**TRANSMITTAL OF RESOLUTION OF THE USEPA
AND OEPA COMMENTS ON THE PSP FOR PILOT
PLANT DRAINAGE DITCH SEEPAGE AND
SURFACE WATER BACKGROUND
INVESTIGATION, MAY 1993**

PILOT PLANT DRAINAGE DITCH SEEPAGE AND
SURFACE WATER BACKGROUND INVESTIGATION

FINAL U.S. EPA AND OHIO EPA COMMENT RESOLUTION

FERNALD ENVIRONMENTAL MANAGEMENT PROJECT
FERNALD, OHIO
REMEDIAL INVESTIGATION AND FEASIBILITY STUDY

USOC⁴¹

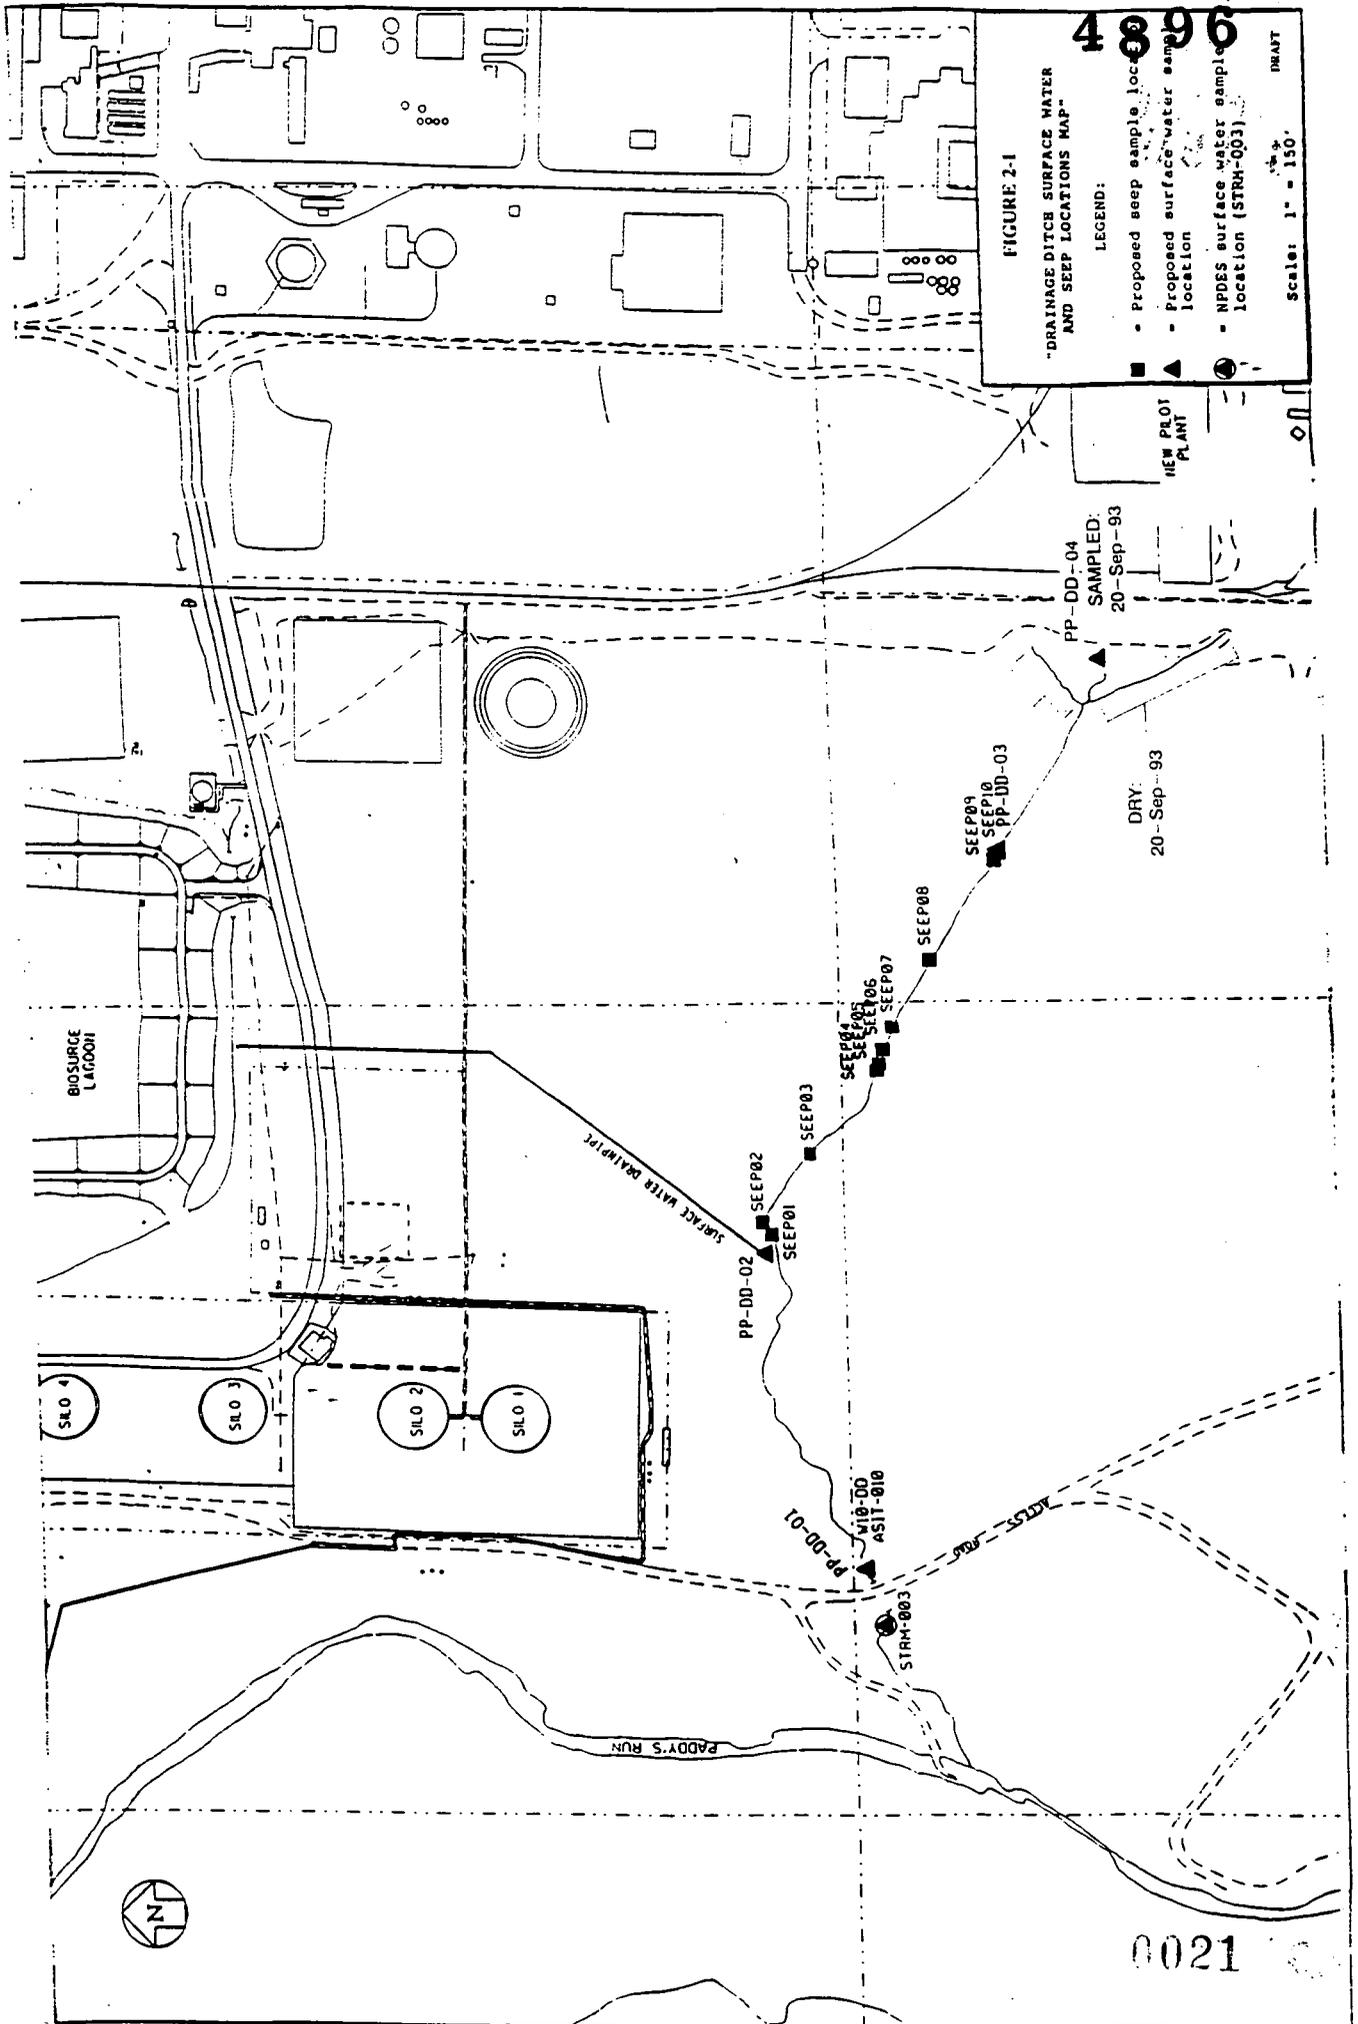
Comment: Figure 2-1 shows the surface water sample PP-DD-03 collection location as just upstream of SEEP10, the seep furthest upgradient from Paddys Run. Since additional seeps may have formed since the drainage ditch site-walk and to better characterize the drainage ditch background contamination level, an additional surface water sample should be collected at the head of the drainage ditch.

Comment: Figure 2-1 shows the surface water sample PP-DD-03 collection location as just upstream of SEEP10, the seep furthest upgradient from Paddys Run. Since additional seeps may have formed since the drainage ditch site-walk and to better characterize the drainage ditch background contamination level, an additional surface water sample should be collected at the head of the drainage ditch.

Resolution: An additional surface water sample was collected at the head of the drainage ditch. Amendment USOC-1 presents the location of Surface Water Sample No. PP-DD-04.

Response: The formation of new seeps was judged to be unlikely as the season changed from spring to summer; therefore, additional samples upstream of observed seeps were not planned. Monitoring wells 11069 and 11070 are being installed in proximity to the head waters of the Pilot Plant drainage ditch. These wells will determine if perched groundwater, which feeds the seeps, is contaminated. If these wells do not detect contamination, then the source may be assumed to be the pipes draining the area under the Pilot Plant where there is known perched groundwater contamination or contaminated runoff.

To further delineate the source of contamination in the ditch, DOE will check the three drainages at the head waters of the ditch to see if sufficient water is present to sample. If sufficient water is present, it will be sampled and analyzed for TAL 50.03.16A plus fecal coliform. Fecal coliform analysis is added to the TAL in response to Ohio EPA comment No. 2.

Action: The PSP will be revised to specify the additional sample locations and analytical requirements
